2010
IMPROVEMENT PLANS FOR
SAHARA AVENUE
BUS RAPID TRANSIT PROJECT
Volume 1

AS-BUILT

Based on Contractor Supplied Information Which Has Not Been Verified By The Louis Berger Group, Inc.

FIELD MODIFICATION NO 24B
ADD DRIVEWAY AND SIDEWALK ACROSS STATE ST (SAHARA WB)
10/18/2011 RTC/ggb

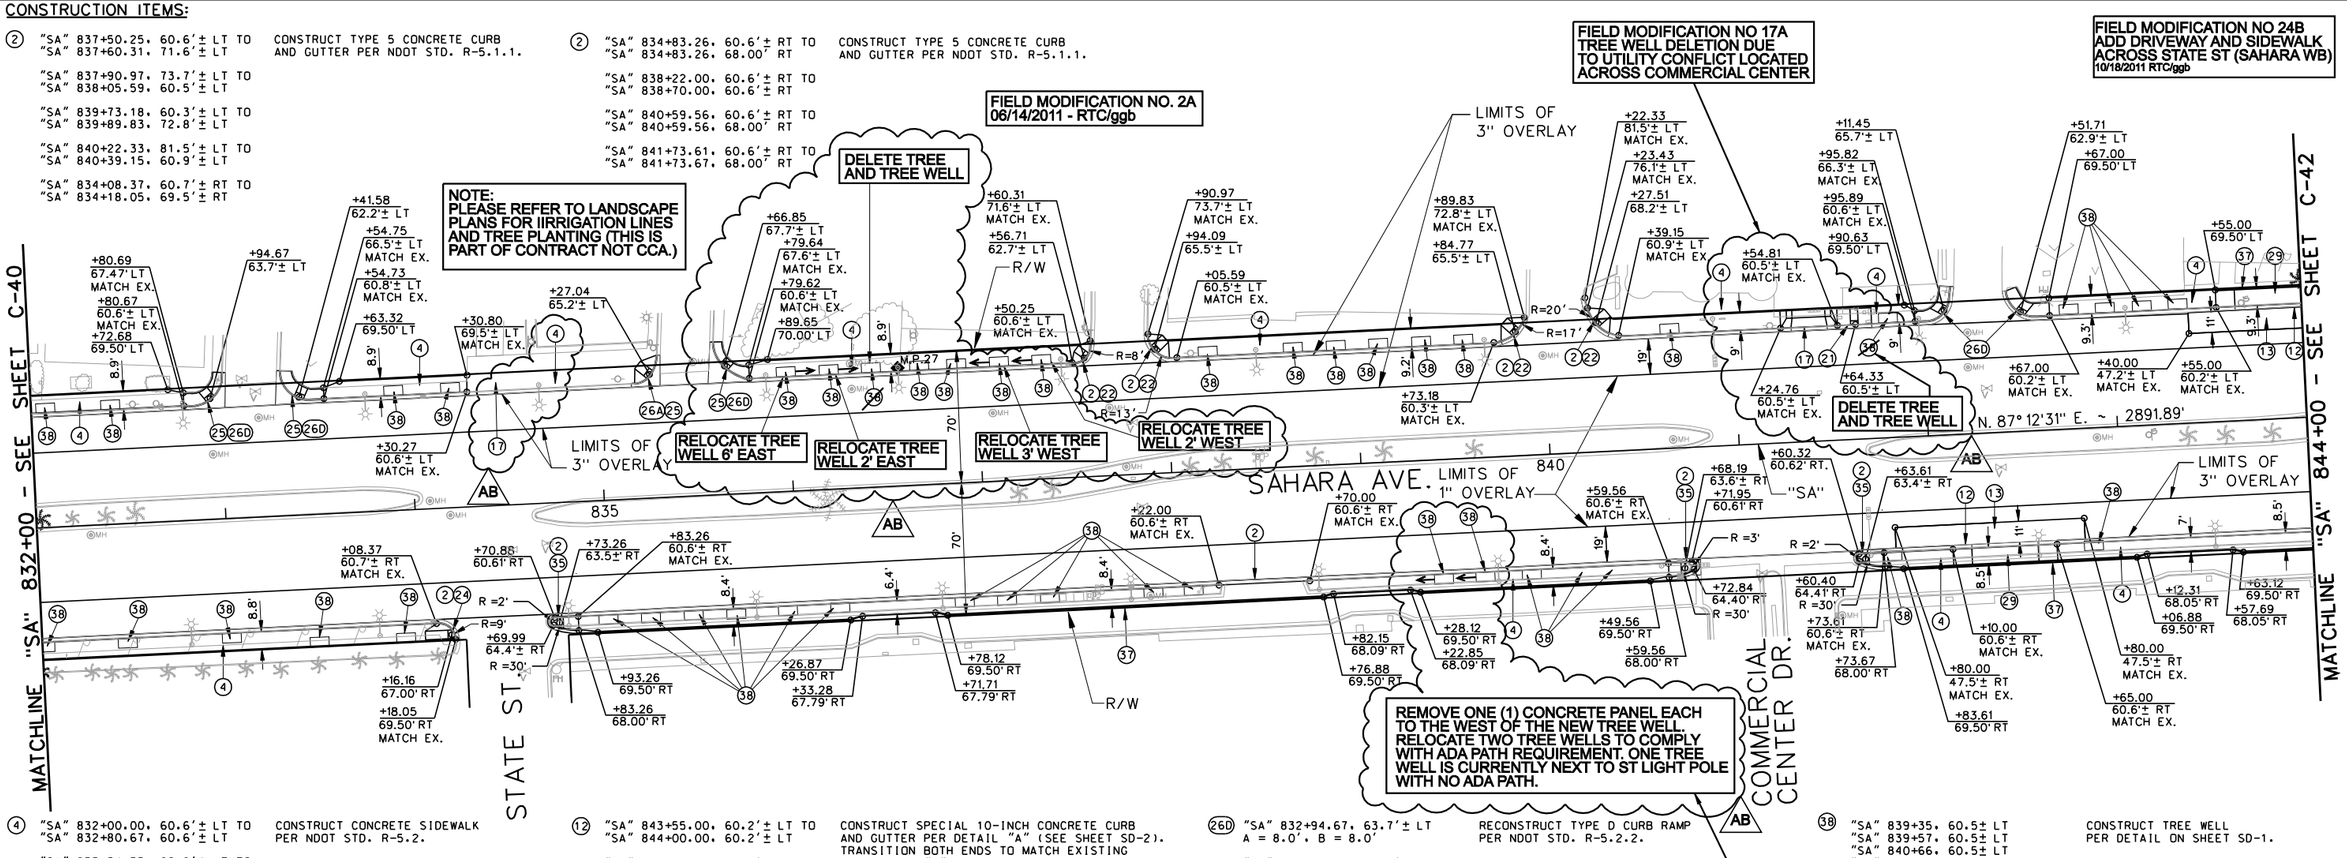
REMOVE ONE (1) CONCRETE PANEL EACH TO THE WEST OF THE NEW TREE WELL. RELOCATE TWO TREE WELLS TO COMPLY WITH ADA PATH REQUIREMENT. ONE TREE WELL IS CURRENTLY NEXT TO ST LIGHT POLE WITH NO ADA PATH.

FIELD MODIFICATION NO. 8
06/14/2011 - RTC/ggb

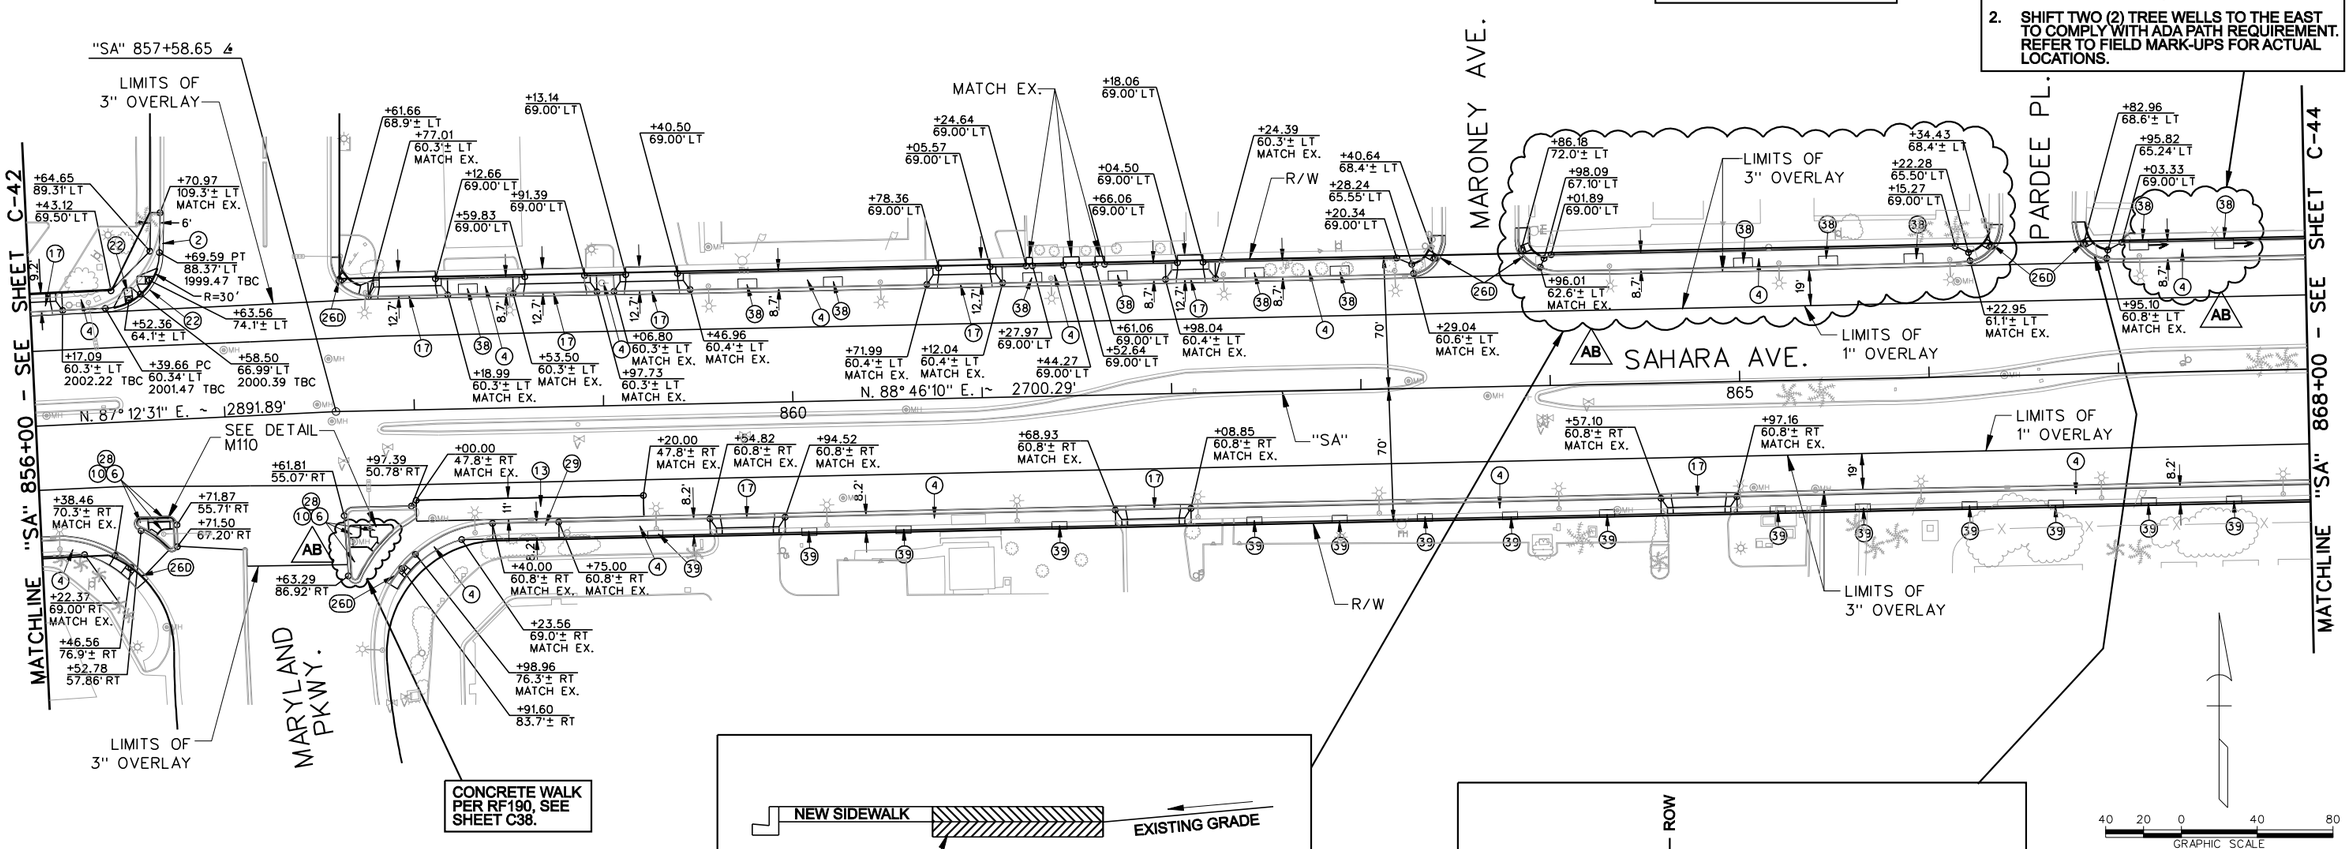
NOTE:
1. TREE WELLS SHALL BE INSTALLED AT THE BACK OF SIDEWALK PER ORIGINAL LOCATION (REFER TO SHEET C43 AND L1.15 DATED 2/11/11).
2. SHIFT TWO (2) TREE WELLS TO THE EAST TO COMPLY WITH ADA PATH REQUIREMENT. REFER TO FIELD MARK-UPS FOR ACTUAL LOCATIONS.

FIELD MODIFICATION NO 13A
TREE DELETION
07 / 27 / 2011 - RTC/ggb

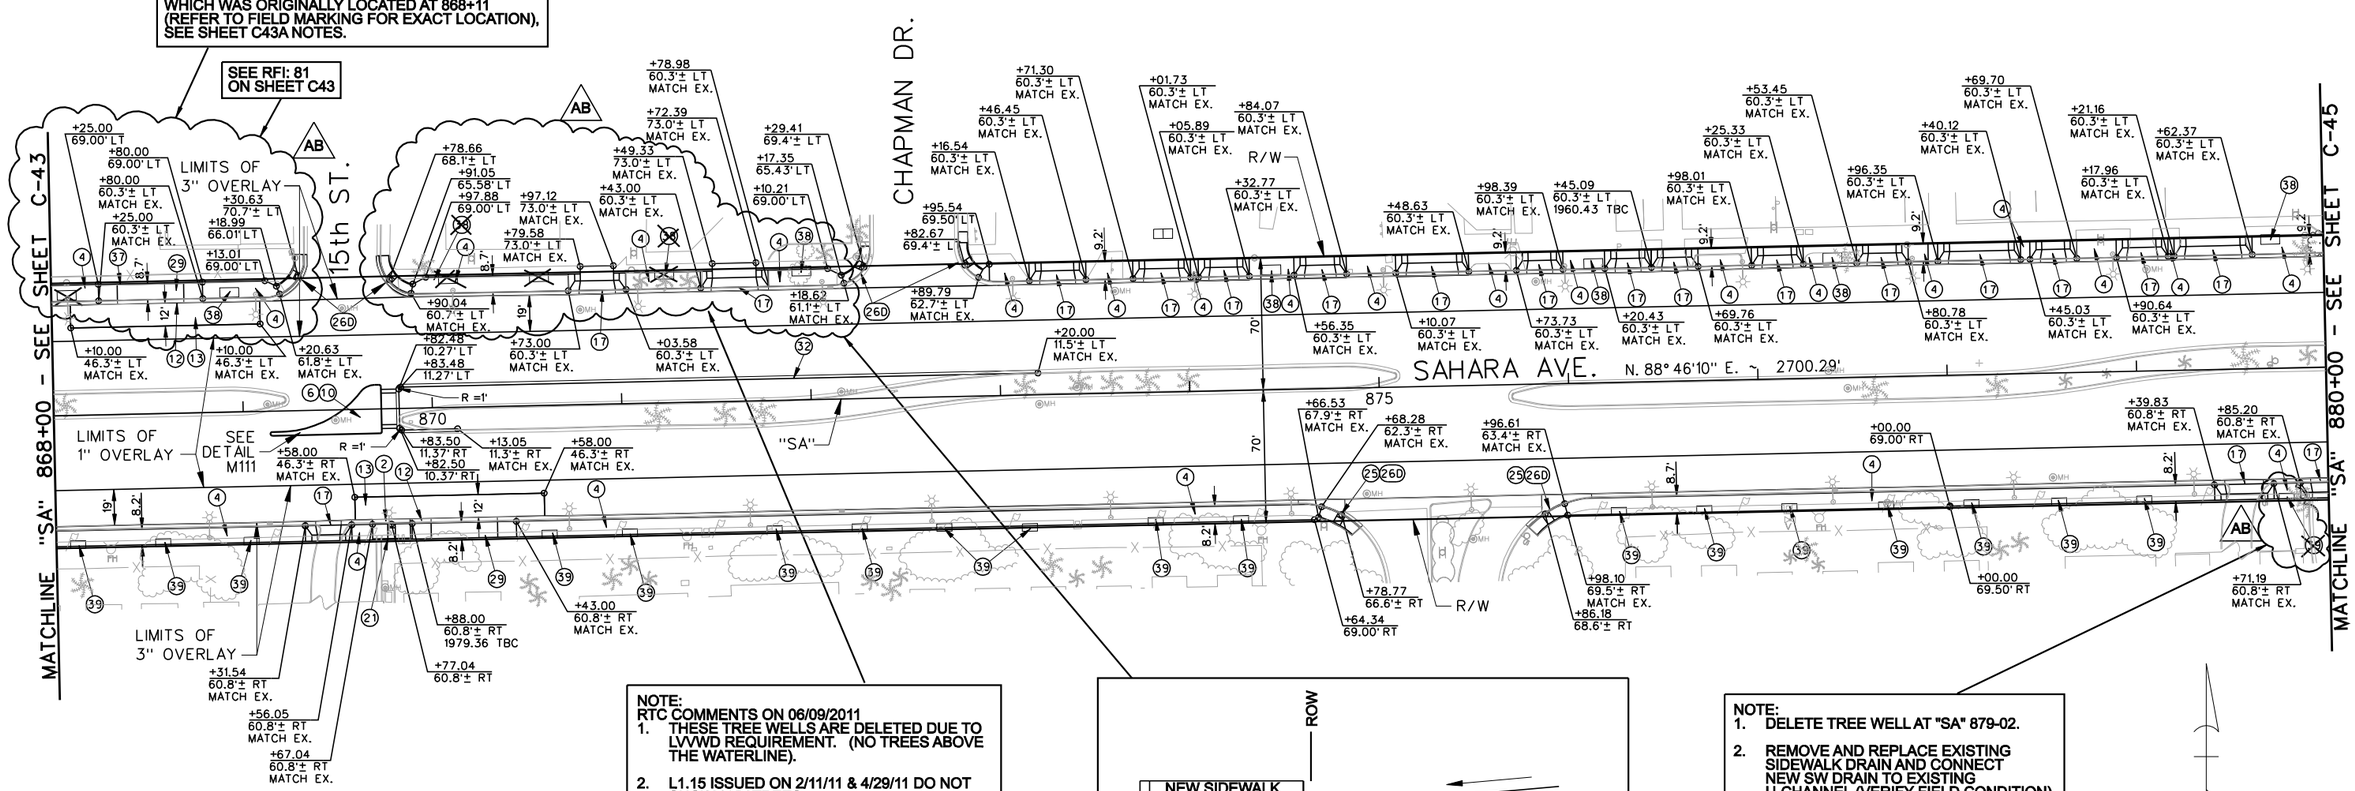
NOTE:
RTC COMMENTS ON 06/09/2011
1. THESE TREE WELLS ARE DELETED DUE TO LVVWD REQUIREMENT. (NO TREES ABOVE THE WATERLINE).
2. L1.15 ISSUED ON 2/11/11 & 4/29/11 DO NOT SHOW ANY TREES.
